S E R V I C E N O T E

HP 8566B Spectrum Analyzer
 HP 8567A Spectrum Analyzer
 HP 8568B Spectrum Analyzer
 HP 85662A IF-Display Section

Misloaded Capacitor Exposed to 130% of Its Rating

Figure 1. Location of A1A10C1 and A1A10C4

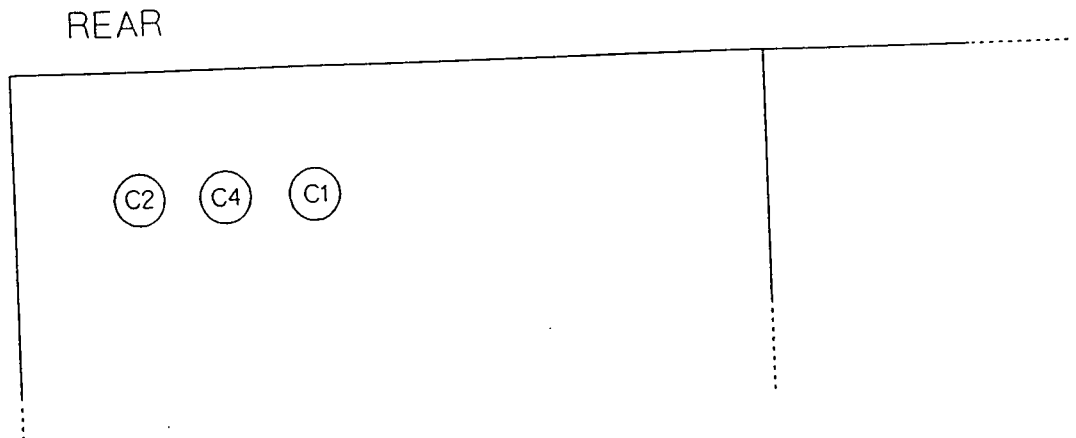
An assembly process variation was discovered that might have resulted in two large electrolytic power supply capacitors being installed in the wrong location in HP 85662A IF-Display Sections within the serial range listed above. When installed in the wrong location, one of the capacitors can be exposed to as much as 130% of its rating. This would probably result in a premature capacitor failure, with possible venting of the capacitor electrolyte onto the bottom of the IF-Display Section. Venting might cause damage to other components and assemblies.

1. Remove the power cords and interconnect cables from the rear of the spectrum analyzer.
2. Loosen the lock feet and separate the RF and the IF sections; set the RF section aside.
3. Remove the 2 rear feet near the top of the IF-Display Section.
4. Remove the top cover and check for proper position of the capacitors (A1A10C1 and A1A10C4). See Figure 1.

8. Remove the 4 screws securing A1A10C1 and A1A10C4 to the motherboard.
9. Remove the existing capacitors and replace with new capacitors, making sure the A1A10C1, 22000 μ F (HP part number 0180-2808), and A1A10C4, 8700 μ F (HP part number 0180-0453), are in the correct locations.
10. Reinstall the bracket, top cover, bottom cover, and the 4 rear feet.
11. Mate the IF and RF sections and reconnect cables. No calibration is required.
